Access Compliance Report Public Rights-of-Way (Curb Ramps)

Main Street: MORNING_TRAIL Cross Street: N/A Location: N

ADA ID: RPAT220208140103 Ramp Type: Type 4 - Parallel Initial Pass/Fail: Fail Overall Compliance: No Severity Score: 2

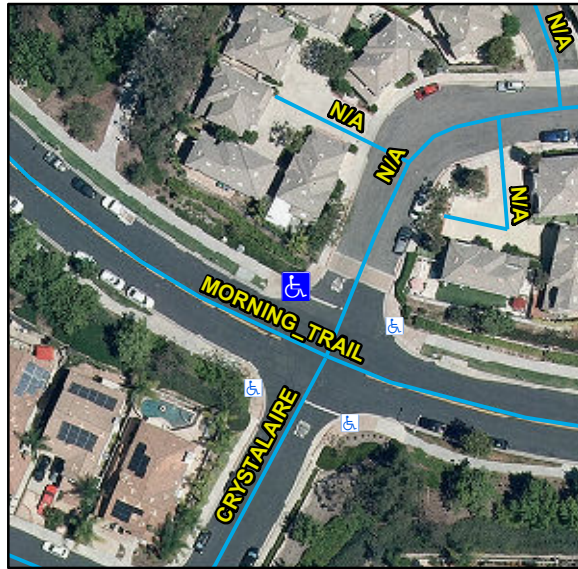
Compliance	Description	Data	Compliance	Description	Data
N/A	Ramp Length LT (in)	107	N/A	Ramp Length RT (in)	122
Yes	Ramp Width LT (in)	78	Yes	Ramp Width RT (in)	67
Yes	Ramp Run Slope LT (%)	4.2	Yes	Ramp Run Slope RT (%)	6.1
No	Ramp Cross Slope LT (%)	4.6	No	Ramp Cross Slope RT (%)	4.3
N/A	Landing Present	N/A	N/A	DWS Provided	N/A
N/A	Landing Length (in)	N/A	N/A	DWS Contrast	N/A
N/A	Landing Width (in)	N/A	N/A	DWS Length (in)	N/A
N/A	Landing Run Slope (%)	N/A	N/A	DWS Full Width	N/A
N/A	Landing Cross Slope (%)	N/A		DWS Offset Type	N/A
N/A	Landing Movement Obstructed?	N/A	N/A	DWS Offset Left (in)	N/A
	Landing Movement Type	N/A	N/A	DWS Offset Right (in)	N/A
N/A	Landing Shared	N/A			
N/A	Clear Space	Yes			
N/A	Clear Space To Crosswalk (in)	N/A			
N/A	Marked Crosswalk 1	No	N/A	Marked Crosswalk 2	No
	Crossing 1 Direction	SW		Crossing 2 Direction	SE
	Marked Crosswalk 1 Width (in)	N/A		Marked Crosswalk 2 Width (in)	N/A

Remove & Replace Curb Ramp With Two New Directional Ramps or Equivalent.

R204.3, R304.5.3, STD 1115
